**Community Development Block Grant Disaster Recovery Program (CDBG-DR)  
Owner Occupied Rehabilitation and Rebuilding Program (OORR)**

**9 CROWN STREET, WATERBURY, CT**

**Addendum # 2  
February 19, 2015**

Sheet #:  
**SKA-021915a**

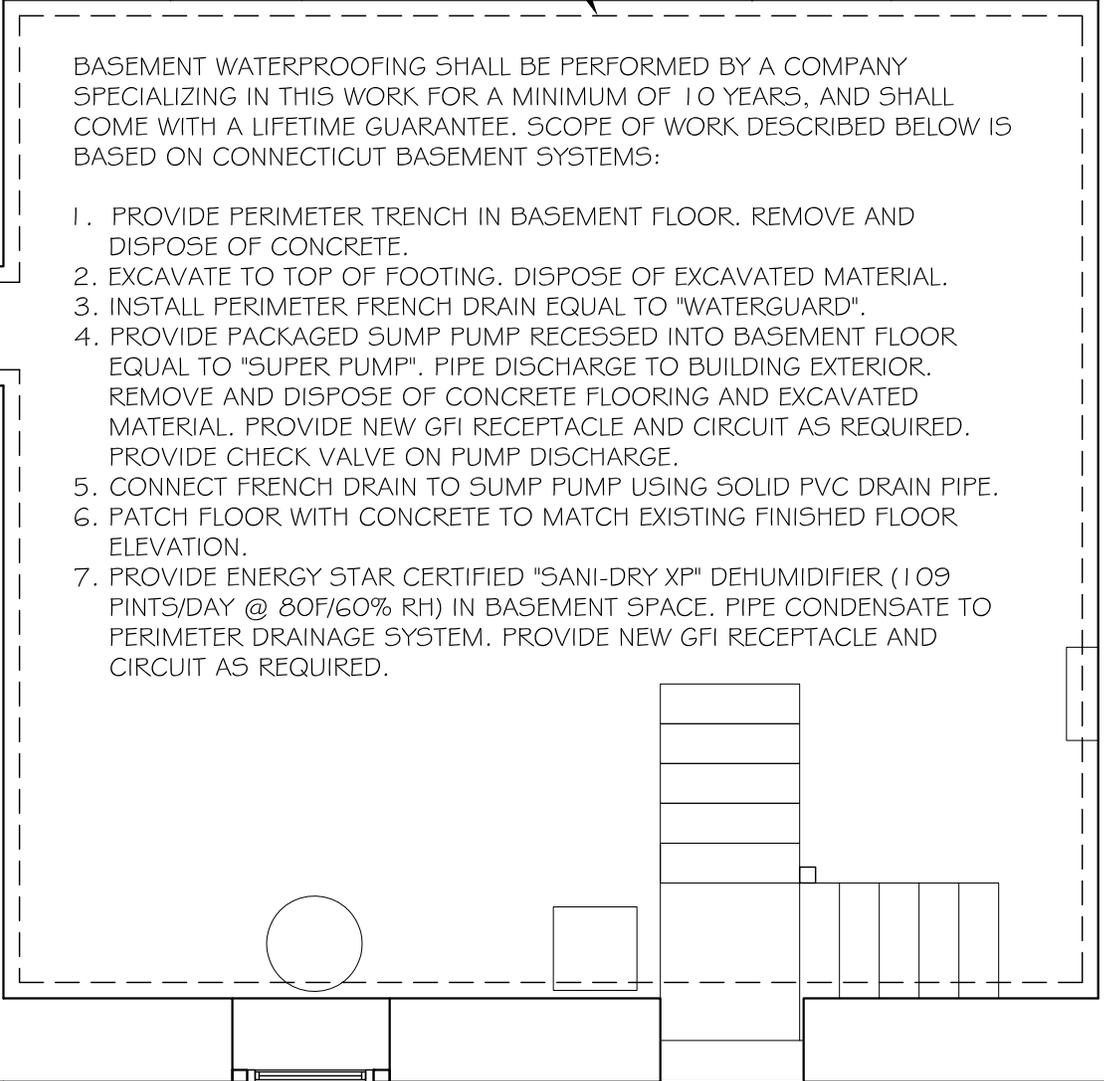
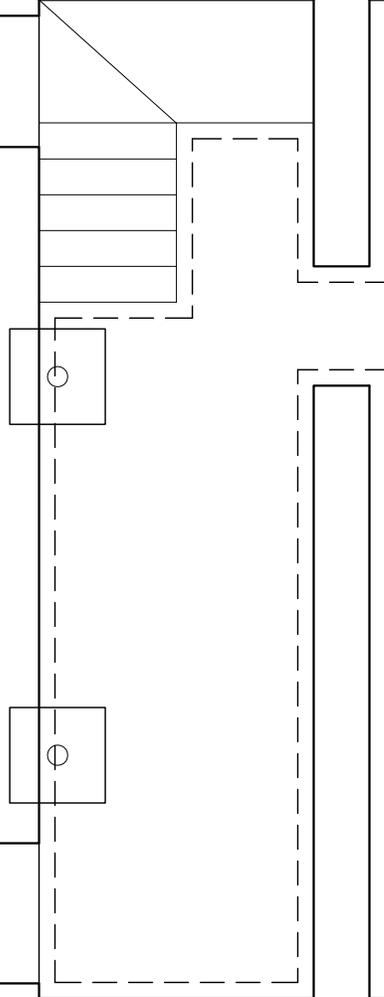
1. See the attached Addendum Sketch – SKA-021915a. It describes the interior drainage system what will be used in lieu of the originally designed exterior drainage system. Replacement of front porch and rear and side steps and landings will still occur as indicated on plans.
2. The work described in Add Alternate # 1 shall be incorporated in the base bid, as the work involved to install the interior drain necessitates it. Refer to Add Alternate # 1 as “N/A” on your bid sheet. Add Alternate #2 and Add Alternate # 3 shall remain.
3. The Bid date originally scheduled for February 17, 2015 is postponed until 4:00 PM on February 24, 2015 – not 4:30 PM as stated on Addendum # 1.

NEW PERIMETER TRENCH

BASEMENT WATERPROOFING SHALL BE PERFORMED BY A COMPANY SPECIALIZING IN THIS WORK FOR A MINIMUM OF 10 YEARS, AND SHALL COME WITH A LIFETIME GUARANTEE. SCOPE OF WORK DESCRIBED BELOW IS BASED ON CONNECTICUT BASEMENT SYSTEMS:

1. PROVIDE PERIMETER TRENCH IN BASEMENT FLOOR. REMOVE AND DISPOSE OF CONCRETE.
2. EXCAVATE TO TOP OF FOOTING. DISPOSE OF EXCAVATED MATERIAL.
3. INSTALL PERIMETER FRENCH DRAIN EQUAL TO "WATERGUARD".
4. PROVIDE PACKAGED SUMP PUMP RECESSED INTO BASEMENT FLOOR EQUAL TO "SUPER PUMP". PIPE DISCHARGE TO BUILDING EXTERIOR. REMOVE AND DISPOSE OF CONCRETE FLOORING AND EXCAVATED MATERIAL. PROVIDE NEW GFI RECEPTACLE AND CIRCUIT AS REQUIRED. PROVIDE CHECK VALVE ON PUMP DISCHARGE.
5. CONNECT FRENCH DRAIN TO SUMP PUMP USING SOLID PVC DRAIN PIPE.
6. PATCH FLOOR WITH CONCRETE TO MATCH EXISTING FINISHED FLOOR ELEVATION.
7. PROVIDE ENERGY STAR CERTIFIED "SANI-DRY XP" DEHUMIDIFIER (109 PINTS/DAY @ 80F/60% RH) IN BASEMENT SPACE. PIPE CONDENSATE TO PERIMETER DRAINAGE SYSTEM. PROVIDE NEW GFI RECEPTACLE AND CIRCUIT AS REQUIRED.
